Service Note		
Product	Description:	Service note no.
<b>D22</b>	<b>Upgrade to 4 x Delay time (5200ms)</b>	<b>720 10 T0 46</b>

### Procedure, if connector J13 is not mounted.

Fig. 2: Location of Ex.RAM board and foam.

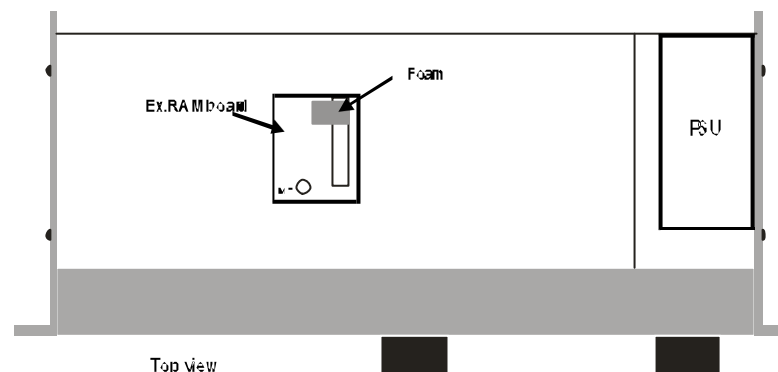
- A. Use a PCMCIA card to make a copy of the user presets.
- B. Turn Off Power and Disconnect Power Cord.
- C. Remove the top lid by loosening five screws, see fig.1.
- D. Replace the old Ex.RAM board at J13 with the new Ex.RAM board. See fig. 2.
- E. Fasten the board to the metal spacer by use of 1 screw and 1 star washer. See fig 2.
- F. Mount the foam piece on top of the Ex.RAM board in the end opposite of the screw if the foam wasn't fitted by TC. See fig. 2.
- G. Mount the top lid.
- H. Load in application software version 2.50 (or higher).
- I. If necessary; load in the user preset. Presets are compatible.

12. Solder in the new 68 pin connector (523056011) as J13
13. Mount the main board again.
14. Mount the new Ex.RAM board at J13. See fig. 2.
15. Mount the foam piece on top of the Ex.RAM board in the end opposite of the screw if the foam wasn't fitted by TC. See fig. 2.

16. Fasten the board to the metal spacer by use of 1 screw and 1 star washer. See fig 2.
17. Mount the top lid.
18. Load in application software version 2.50 (or higher)

Fig. 4: Location of MT12 and J13.

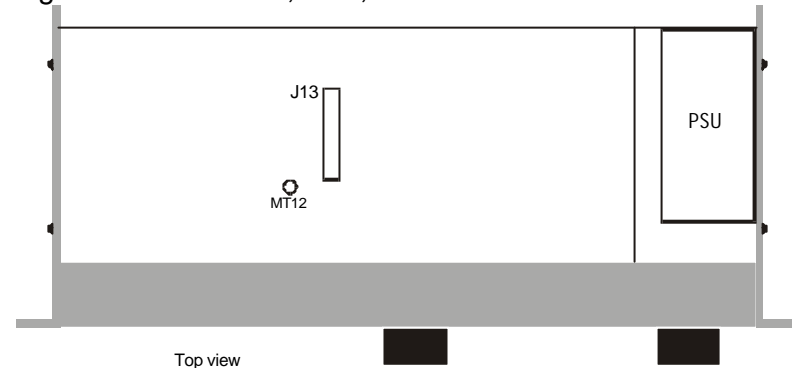
10. Push the main board into the front profile a little to free the connectors from the back panel, then lift out the board.
11. Mount the metal spacer (566007030) at MT12 by use of 1 screw (563005030) and 1 star washer (565052030). See fig 4.
